PLANNING & DEVELOPMENT SOLUTIONS

RE: MINOR CHANGE (S81) APPLICATION TO DEVELOPMENT APPROVAL FOR MATERIAL CHANGE OF USE (IMPACT ASSESSMENT) FOR A MULTIPLE DWELLING DEVELOPMENT (16 UNITS) AT 59 & 61 THISTLE STREET, LUTWYCHE – LOTS 4 & 5 ON RP19359

Please accept this correspondence on behalf of the Applicant as a properly made change application in accordance with Section 78 of the Planning Act 2016 ('Planning Act') for a proposed minor change to the existing approval.

Figure 2 – Proposed Level 5 floor plan (comparison plans, Esat Design)

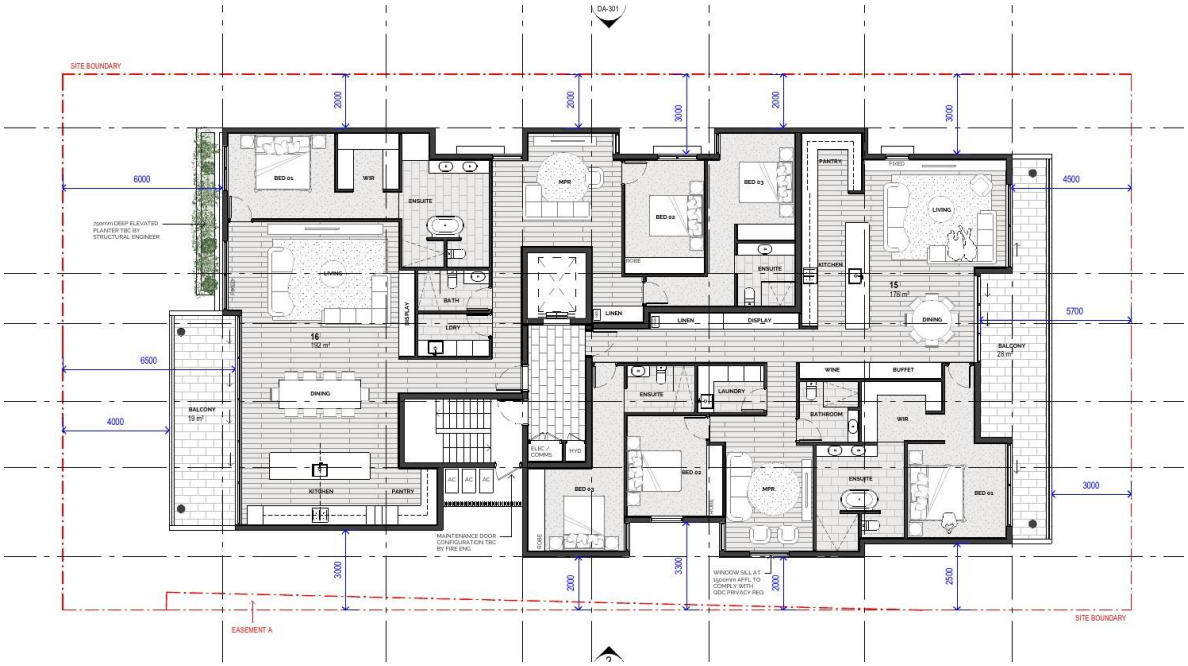
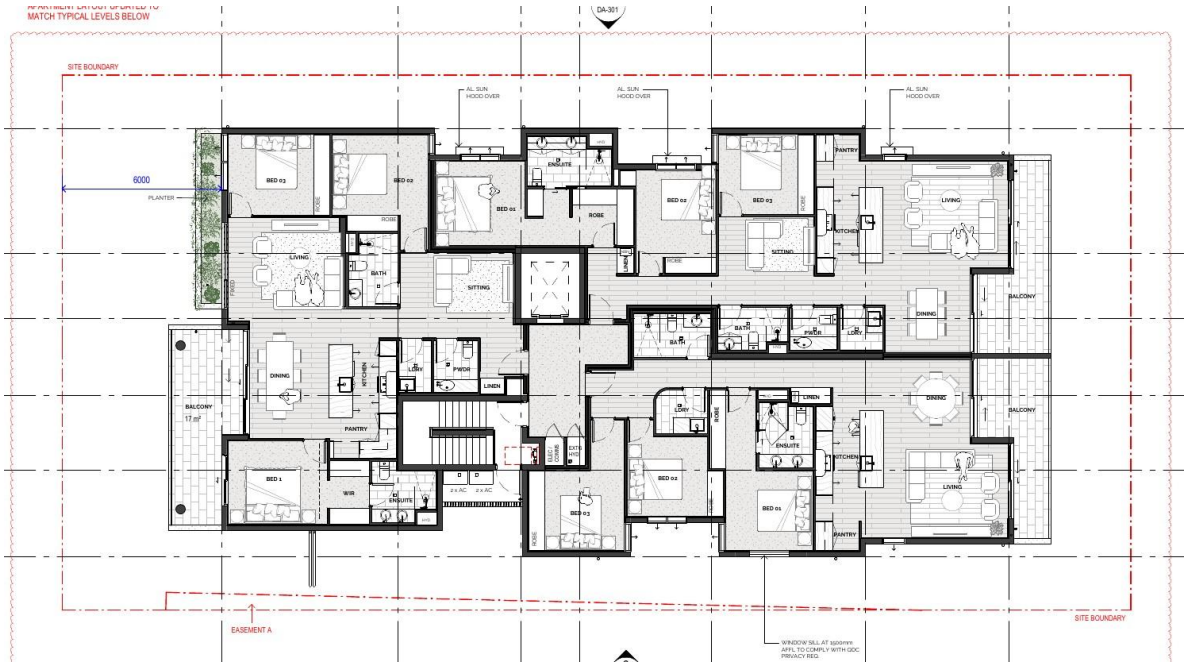
The approved development provides two larger apartments on Level 5 (176m^2 and 192m^2). In response to market demand and falling property prices, it is proposed to reconfigure Level 5 to provide three three-bedroom apartments (125m^2, 119m^2 and 111m^2), consistent with the layout of Levels 1 to 4 below. This increases the yield from 16 to 17 apartments, all of which contain three bedrooms.

The additional apartment is accommodated wholly within the approved Level 5 floor plate. The approved rear balcony (28m^2) and front balcony (19m^2) on Level 5 are replaced with three balconies (17m^2, 14m^2 and 13m^2) that match the levels below.

Figure 6 – Proposed ground level plan (comparison plans, Esat Design)

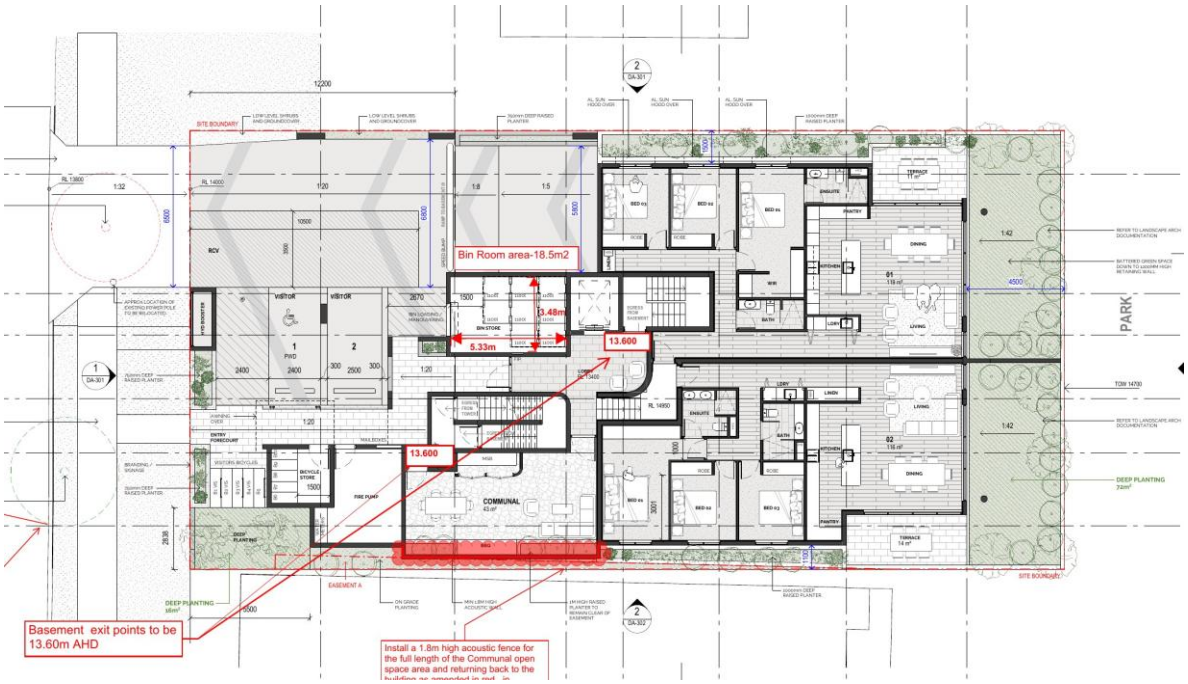
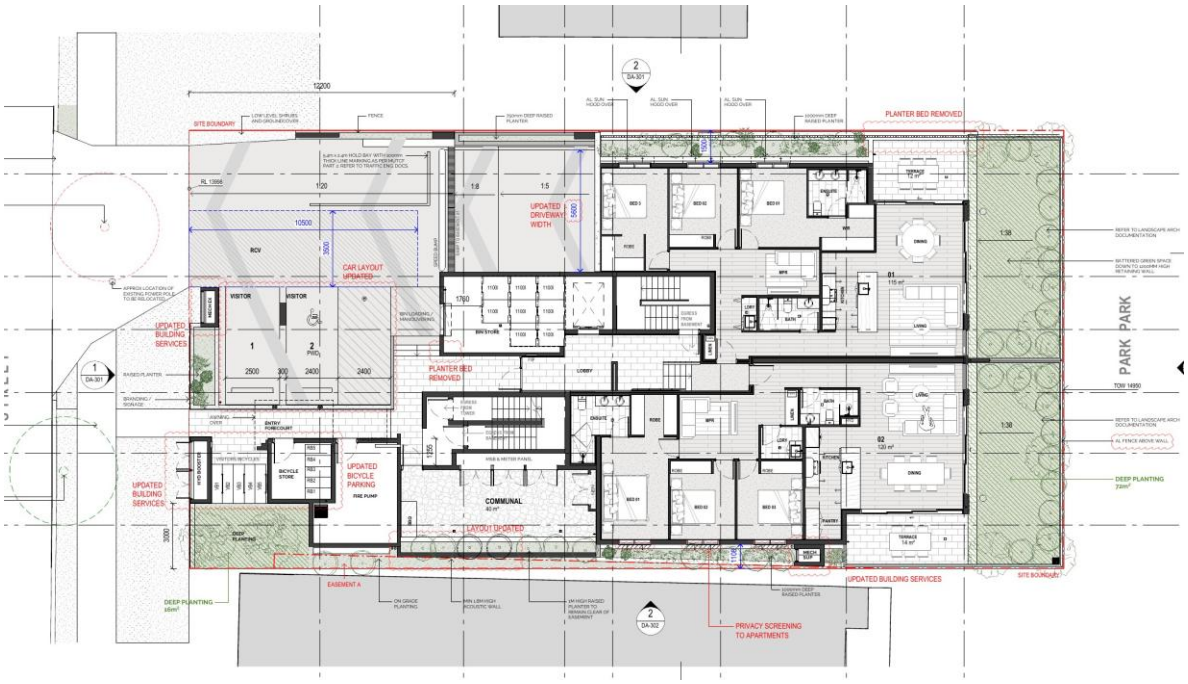
- A new egress door at the Upper Basement 01 level;
- Minor refinements at ground level, including the visitor bay arrangement (Bay 1 marked "reverse in only" and Bay 2 PWD with an adjacent shared area) and line marking of the 5.4m x 2.4m hold bay at the signal hold point; and

The amended ground floor plan removes two planter beds, being the planter adjacent to the bin store and a planter adjacent to the Unit 1 terrace. The overall deep planting provision is maintained and the landscape outcome remains consistent with that approved.

The communal open space remains in its approved location at ground level, adjacent to the lobby, and continues to provide BBQ facilities. Its area is amended from 43m^2 to 40m^2 as a result of the refinement of the adjoining fire pump room, egress stairs and services. The 1.8m high acoustic wall required by Council's red amendment to the approved plans is shown on the amended plans. The basement egress point is shown at RL 13.998m AHD, above the minimum 13.60m AHD required by Council's red amendment, and the height clearance signage to the two Basement 2 bays will continue to be provided in accordance with the approval.

Figure 8 – Proposed Basement 1 plan (comparison plans, Esat Design)

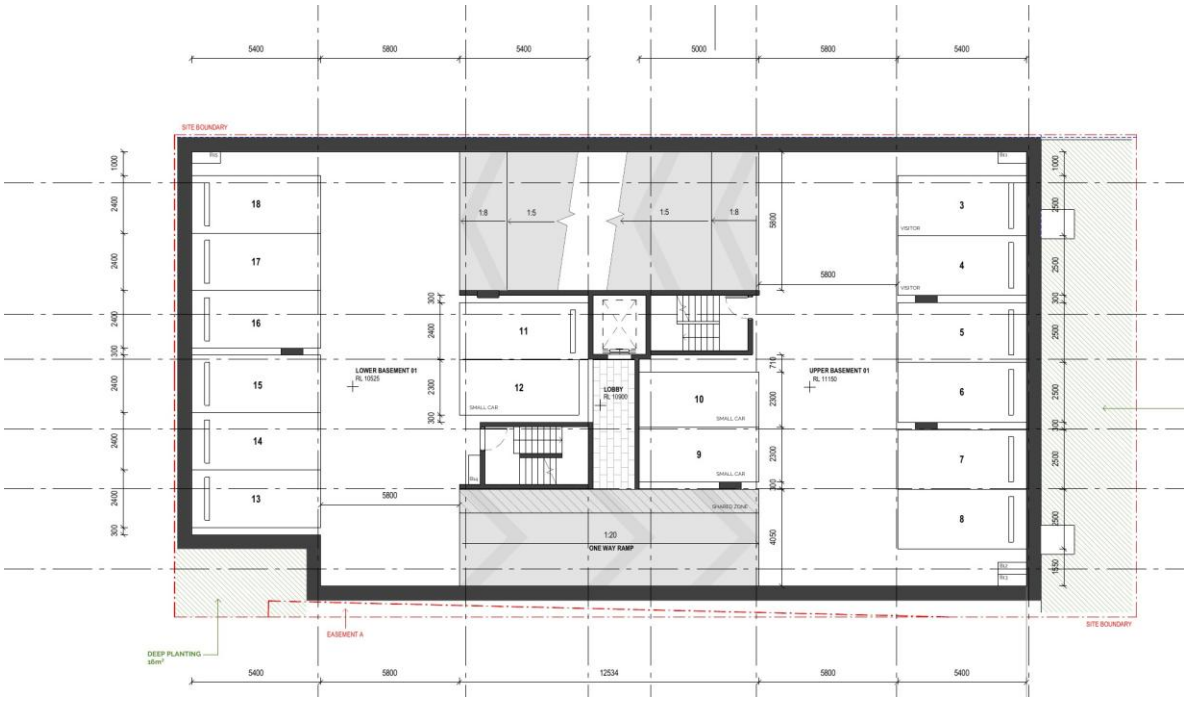
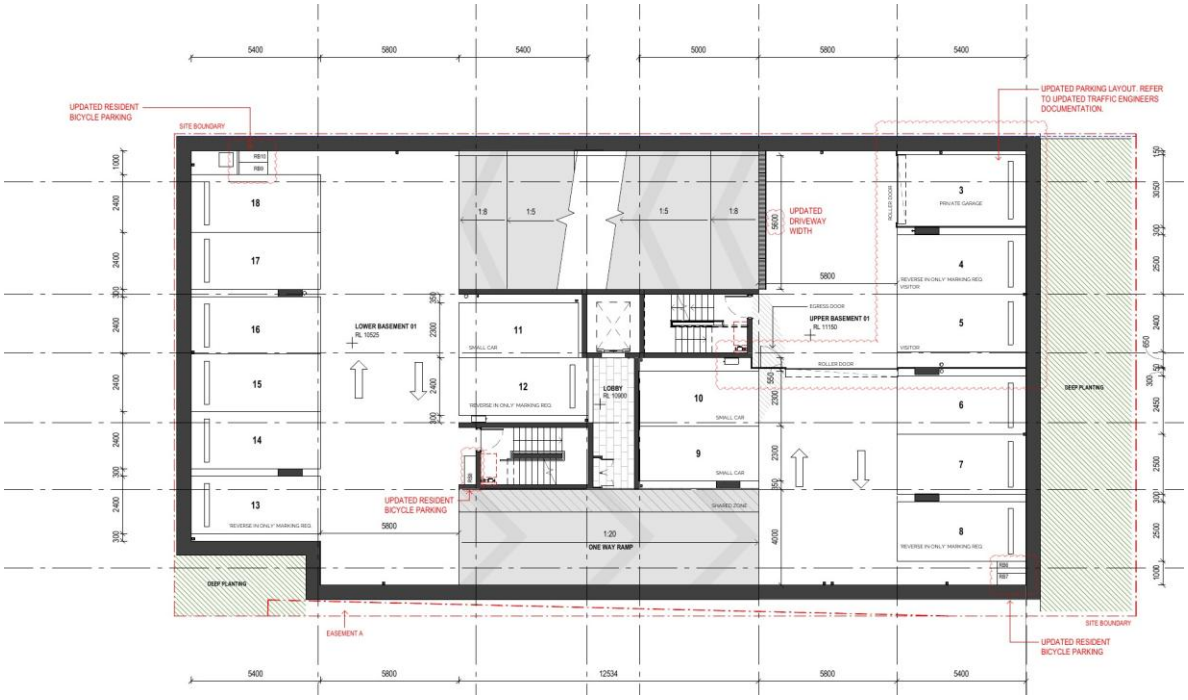
- Parking Bay 3 in Basement 1 converted into an enclosed single private garage with a roller door, including a relocated column;
- The two Basement 1 visitor bays re-allocated from Bays 3 and 4 to Bays 4 and 5;

- A security roller door (4.65m opening) across the Upper Basement 01 aisle, separating the visitor bays from the resident parking area, operated by remote control for residents and guest intercom for visitors;

- Increased clearance (0.65m) between Bay 5 and the adjacent wall and door structure;
- The internal driveway ramp reduced in width from 5.8m to 5.6m at the ground level and Basement 1, which continues to operate as a single-lane ramp under the approved one-way signal control system. ITE Consulting's swept path analysis (Attachment D, Appendix B, Drawing 01) demonstrates B99 vehicle movements at the site access, hold bay and ramp;
